PHEASANT AVIARY

Drng. No. KNP/ZOO/BP/AR-01

LAYOUT PLAN

(45th meeting of Exp. Com. on Zoo Designing. 31/11/17)

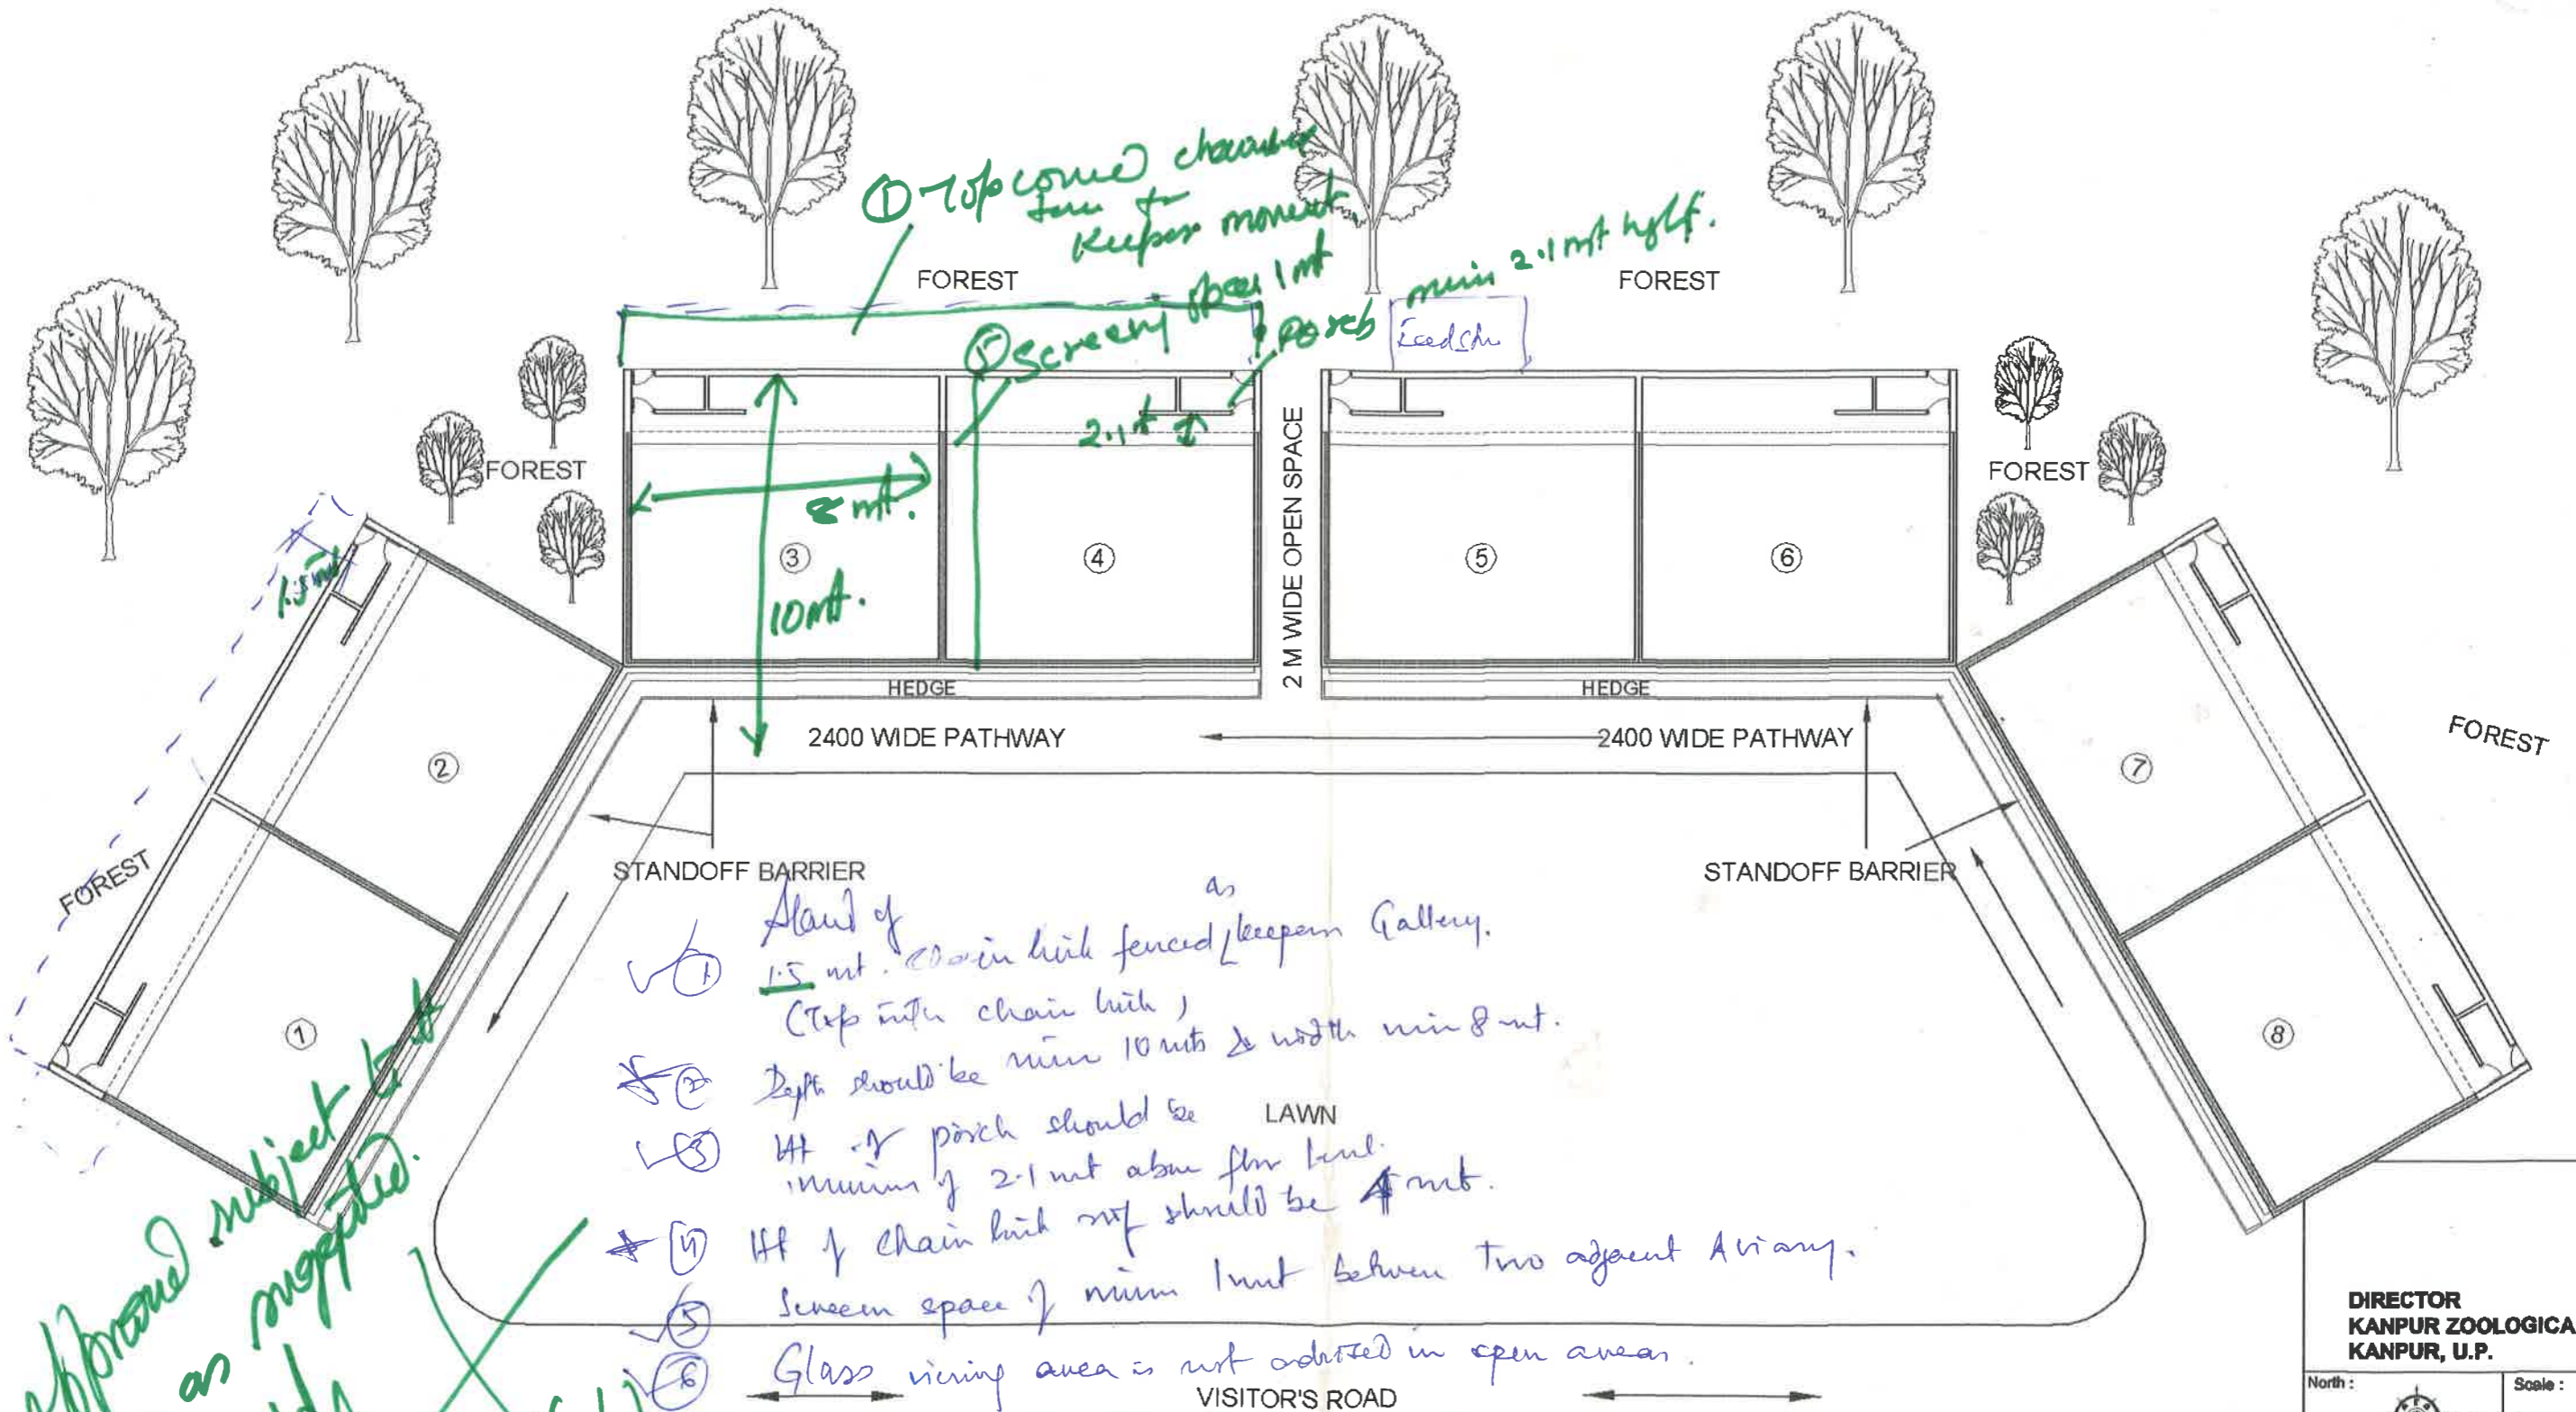
- ① Stand of 1.5 mt. chain link fenced as keeper's Gallery. (Top with chain link)
- ② Depth should be min 10 mts & width min 8 mt.
- ③ Ht of porch should be min of 2.1 mt above floor level.
- ④ Ht of chain link net should be 4 mt.
- ⑤ Screening space of min 1 mt between two adjacent Aviary.
- ⑥ Glass viewing area is not advised in open areas.

② Corners should not be sharp.

③ Provision of appropriate enrichment

Approved subject to changes as suggested.
